IEEE802.3 4P Task Force

Figure 33-17.1 - PSE-PD simplified Cport interpretation model

Comment [clause 33.3.7.3 page 132 line 11]

Figure 33-17.1 - PSE-PD simplified Cport interpretation model. Yair Darshan. Rev 001 November 2015.

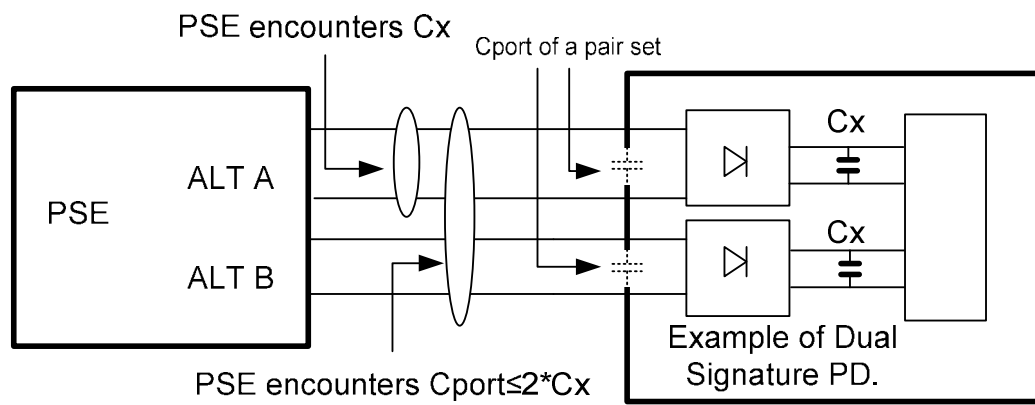
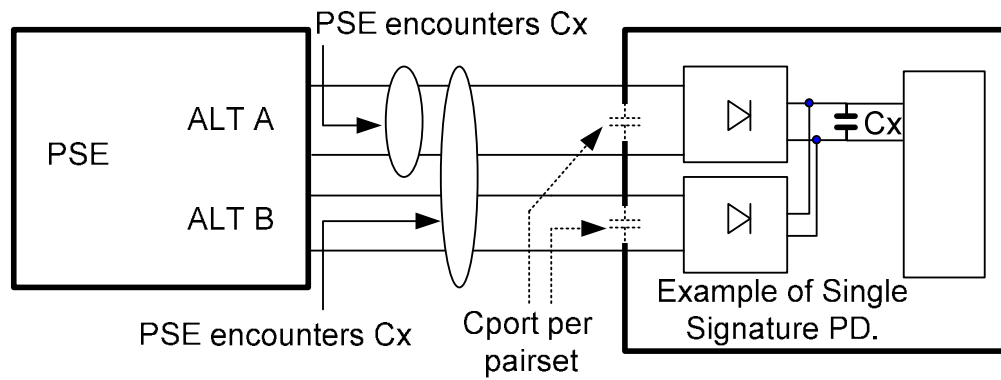
This is the response to the remedy of comment # 150 in D1.3 which says:

"Yair is invited to provide figure and new text (no Annex)".

1. Change from:

"Cport in Table 33-18 is the total PD input capacitance during POWER UP and POWER ON states that a PSE sees when connected to a single-signature PD over a pairset or both pairsets. When PSE is connected to dual-signature PDs, Cport value requirements are specified in 33.3.7.6."

To:

Cport in Table 33-18 is the total PD input capacitance during POWER UP and POWER ON states that a PSE sees when [operating one or both pairsets, when](#) connected to a single-signature PD. ~~over a pairset or both pairsets.~~ When PSE is connected to dual-signature PDs, Cport value requirements are specified in 33.3.7.6."

[See Figure 33-17.1 for PSE-PD simplified Cport interpretation model.](#)"

2. Add figure 33-17.1 after the above text as described in [page 3 of darashan_02_1115.pdf](#).
